Town of Erie, Colorado Development Referral

Location: West of the Intersection of N. 119 th Street & Jasper Road on the south			
Project: Wise FarmsApplicant: Jasper Land Investments, LLCDescription:Rezoning, Planned Unit Development Overlay & Preliminary Plat			
Applicant: Jasper Land Investments, LLC			
Date: January 4, 2017			
Extraction Oil & Gas, LLC			
XCEL Energy			
RTD			
Kerr-McGee Oil & Gas Onshore, LP			
NCWCD & Subdistrict			
Stone Landscape Architects, LLC			
Karage Town of Erie Parks & Recreation			
Town of Erie Engineering

Subject: Wise Farms, Rezoning, Planned Unit Development Overlay & Preliminary Plat

PROJECT: Wise Farms Rezoning, Planned Unit Development Overlay and Preliminary Plat FHU # 95-190

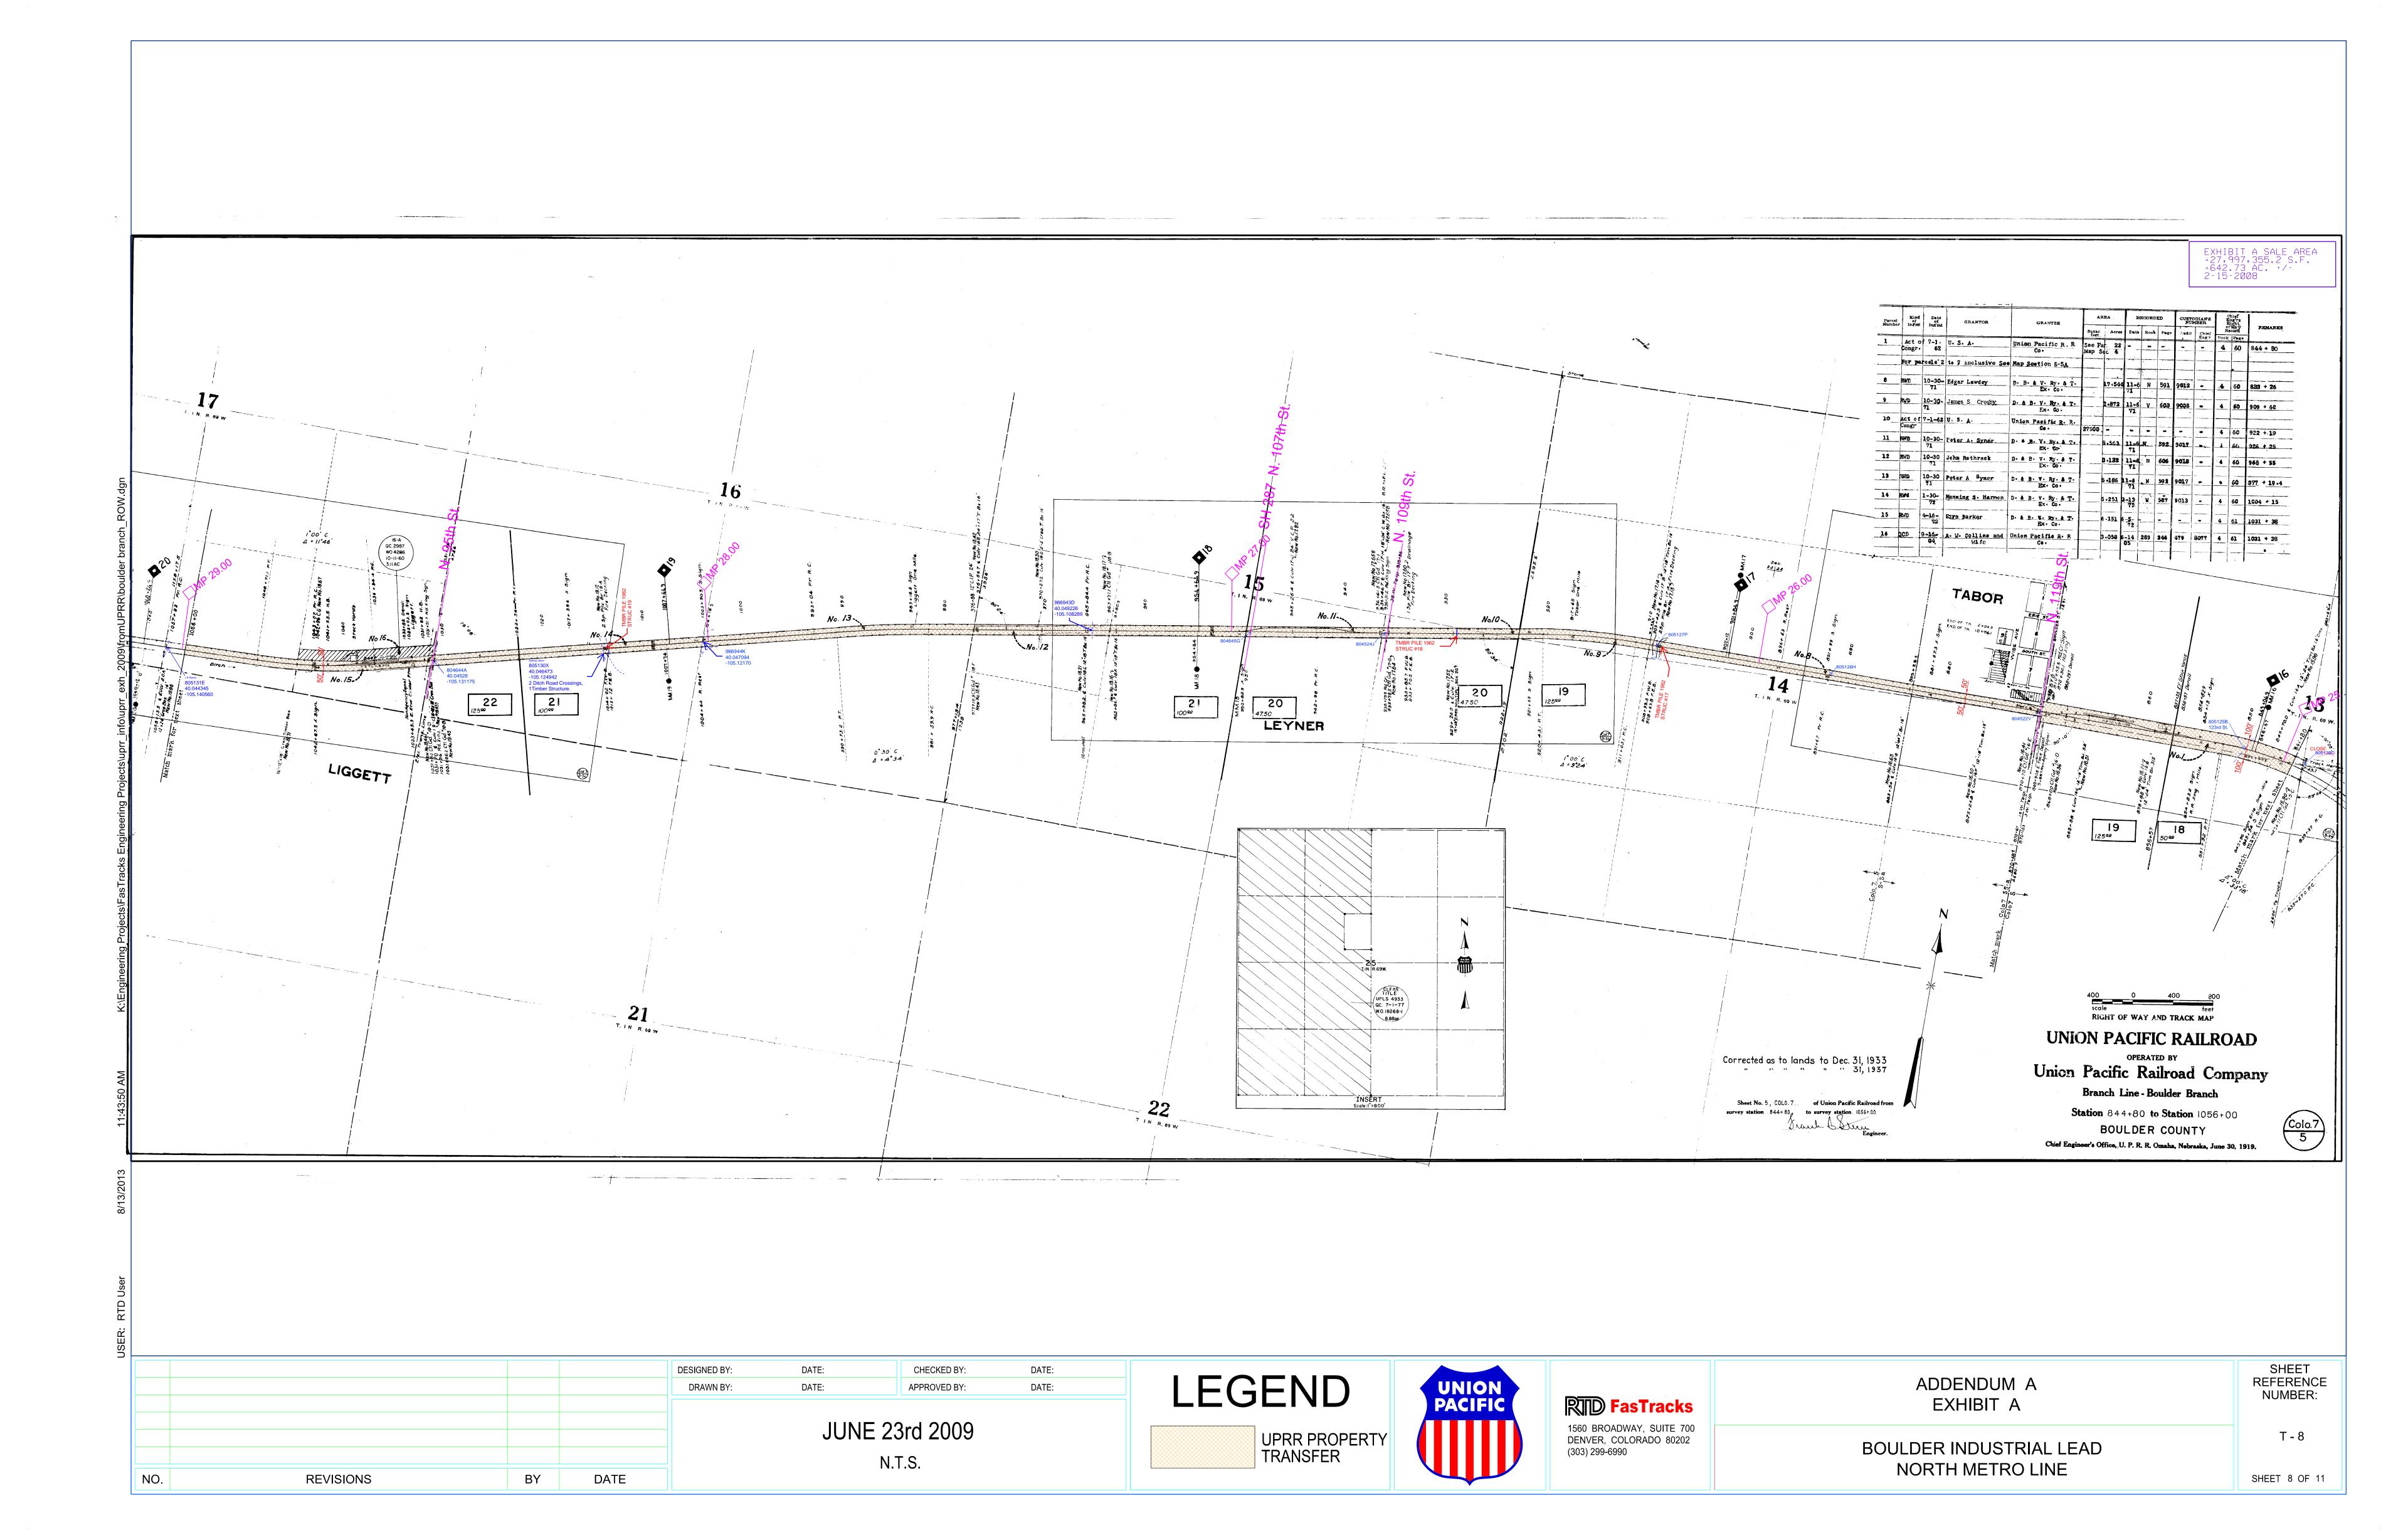
1. P W R C y	 Wayne.Cochran@rtd-denver.com Cell 303-519-8931: Please see attached exhibit for what we believe is RTD's Right-of-way (ROW) through this area, which we call Boulder Industrial Lead (BIL). The Boulder County Assessor's Office web site indicates that the RTD BIL ROW is not continuous through the development area. A land locked parcel of the BIL ROW is recorded as owned by the City of Erie. The Land Title Survey Sheets 22,23, and 24 of the Preliminary Development refer to the subject parcel as Area of Concern #4. Please provide documentation as to why you believe this area is owned by the City of Erie. RTD does not grant easements. Please contact Susan Altes, RTD's Senior Manager of Real Property 				
Susan.Altes@RTD-Denver.com 303-299-2440.					
	Construction Phasing, Duration, and ImpactImpacts known				
	Drainage Impacted Potential Impact No Impact				
 Yong K. Song, PE, CFM, <u>Yong.Song@RTD-Denver.com</u> 303-299-2172 The developer shall submit an application to obtain a RTD Utility Agreement to cross RTD's track right-of-way (ROW) for the proposed storm drain (SD) culvert crossing. The method of construction for the proposed SD crossing under the RTD trackway shall be clearly defined.

- 4. The emergency spillway for the proposed Pond 340 shall be designed to prevent erosion of the RTD's track ROW.
- 5. It appears that the proposed project will increase impervious areas (wells access road and facility pad for oil and gas operations, Street A, trails, etc.) for Sub-basin 130. However, no improvements are proposed to mitigate the increased flows and water quality impacts for Sub-basin 130. Please explain how the flow and water quality impacts will be mitigated prior to flows entering RTD's ROW.

- 6. Please provide existing and proposed conditions hydrologic computations and contours for Subbasin 130 to demonstrate that the project will not increase the flow quantities and change the flow type (sheet vs. concentrated) reaching the RTD ROW.

Erosion concerns	Impacted	Potential Impact	No Impact
	I		
Utilities	Marked Impacted	Potential Impact	No Impact
Jim Kelley (<u>James.Kelley@RTD-Denver.com</u>) (303) 299-6975			
RTD has a process to evaluate requests to cross RTD's right of way and facilities with an OH (overhead) or UG (underground) utility. Please see http://www.rtd-denver.com/UtilityAgreements.shtml for information			
about this process, and technical requirements. Approval is not guaranteed and is not granted until an			
Executed License is issued by RTD Real Property. The comments below are high level comments, and the			
applicant needs to work through the Utility Agreement process.			
of the northwest corner of Based upon the topograpl	the South Parcel (Trac ny shown on the drai proposed Pond 340 poi	tention Pond 340 located approx t C). The pipe is shown to be bo nage plan, the existing ground nd bottom is at 5032. A propose t just 4 feet.	red under RTD ROW. (RTD ROW) is at an

- 2. 8-inch Water A water crossing is proposed at a location approximately 1000 feet east of the northwest corner of the South Parcel (Tract C). A proposed profile is necessary to confirm the proposed depth at the crossing.
- 3. 8-inch Sanitary Sewer- A sanitary crossing is proposed at a location approximately 1020 feet east of the northwest corner of the South Parcel (Tract C). A proposed profile is necessary to confirm the proposed depth at the crossing.
